From: Garril Page (POP) <obility@comcast.net>
Sent: Sunday, November 9, 2025 12:13 PM
To: Julie McMillan; Elizabeth Robbins; Teri Dowling; Mathew Salter; Bill Kircher
Cc: Cyndie Martel
Subject: [EXTERNAL] Agenda Item 12, November 13, 2025
Attachments: Proposed Mitigations page.eml

Appendix B. Martin/Martin Report fully discloses the alarmingly limited nature of their structural assessment. In both Martin/Martin's **Structural Implications of BB2 Removal** and two Advisory Board Zone 9 Flood District handouts from their August 21, 2025, meeting, one endangered, inadequately mitigated structure is glaringly obvious. #540 San Anselmo Avenue (see penciled arrow in Figure 1 below) is identified as needing mitigation and being "A structure supported within the bed of San Anselmo creek is not able to withstand forces associated with the modeled BFE rise".

Exhibit No., 23: 546-538 San Anselmo Ave., San Anselmo and Figure 1. Map of Rise, Effect, and Mitigation Results below indicate 540 San Anselmo Ave needs mitigation and describe "reinforcing Fiber-Reinforced Polymer (FRP) layering on wingwalls to increase strength and durability."

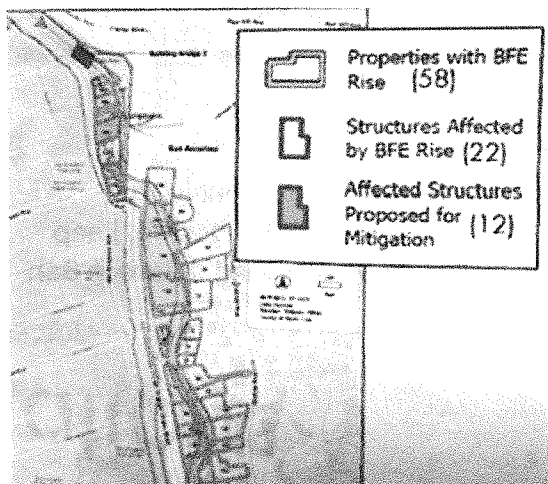
However, the MT-2 Application where other downtown structures not evaluated for scour or assessed beyond visual observation are deemed to meet the acceptable structural performance threshold with minimal code-required reinforcement, #540 is lumped wrongfully into in the 546-538 structural mitigations. The mention that #540 San Anselmo Ave remains unable to withstand the 100 year flood and *not acceptable* even with recommended reinforcement measures and Proposed Mitigation is not discovered except by careful matching of AB's material with the MT-2 Application.

Compare those with the attached handout Proposed Mitigations from the Zone 9 AB meeting below with "A structure supported within the bed of San Anselmo Creek is not able to withstand forces associated with the modeled BFE rise". #540 is not named as unable to survive the project's modeled 100 year flood.

Obviously, greater concern is warranted for 540 San Anselmo Avenue. Yet nowhere in the MT-2 Application except the one reference above would indicate 540 SA Ave would not perform acceptably. The more detailed excerpts below confirm that even with the inclusion of minimum code required reinforcement the wall (540 SA Ave) "does not have adequate reinforcing to withstand the
